SUBJECT: Dual Motor Electric PV 00002-534-13 & Polyhawk 00002-560-07

Swenson has learned the drive sprockets on the gearbox and conveyor electric motor may be misaligned which could possibly cause damage to the electric motor shaft. Units with serial numbers 0411-XXXX and newer, or units shipped after 5/1/2011 are not affected by this service bulletin. Please inspect and repair any spreaders in your inventory and submit a warranty claim. Swenson will reimburse for .5 labor hours per unit to perform this repair.

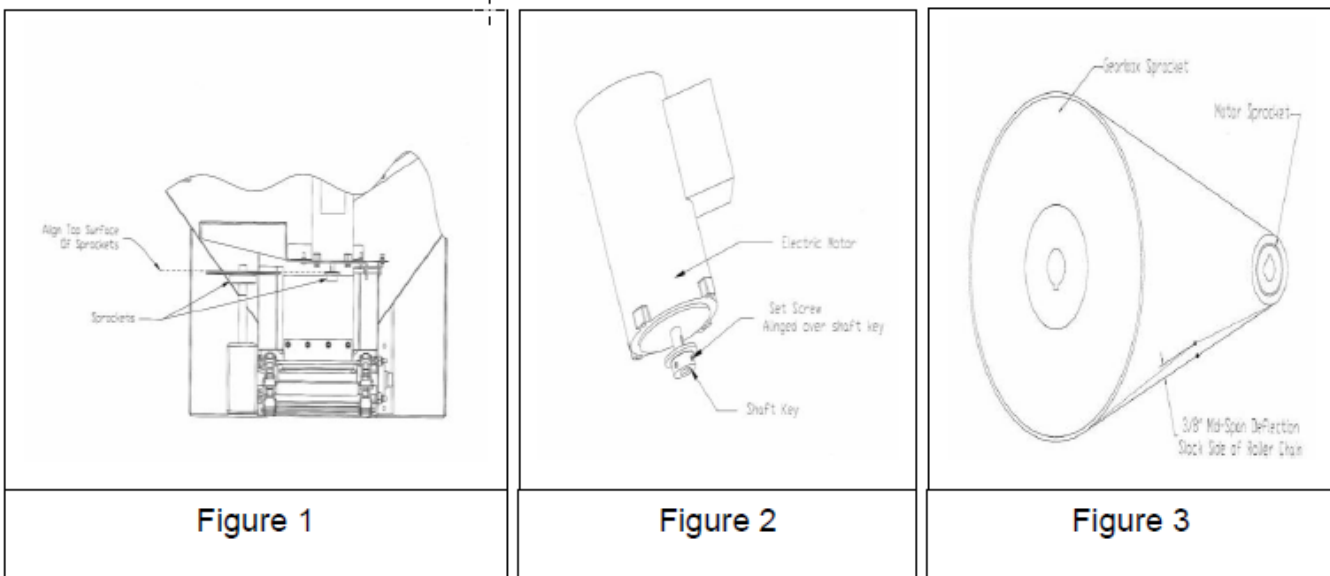
1. Gearbox and conveyor drive motor sprockets are aligned horizontally (see figure 1 below).
2. Shaft keys are aligned with sprockets and set screws are properly tightened (see figure 2 below).
3. Roller chain between conveyor drive motor and gearbox is tensioned to allow for 3/8" deflection midway between sprockets on the slack side of roller chain (see figure 3 below).
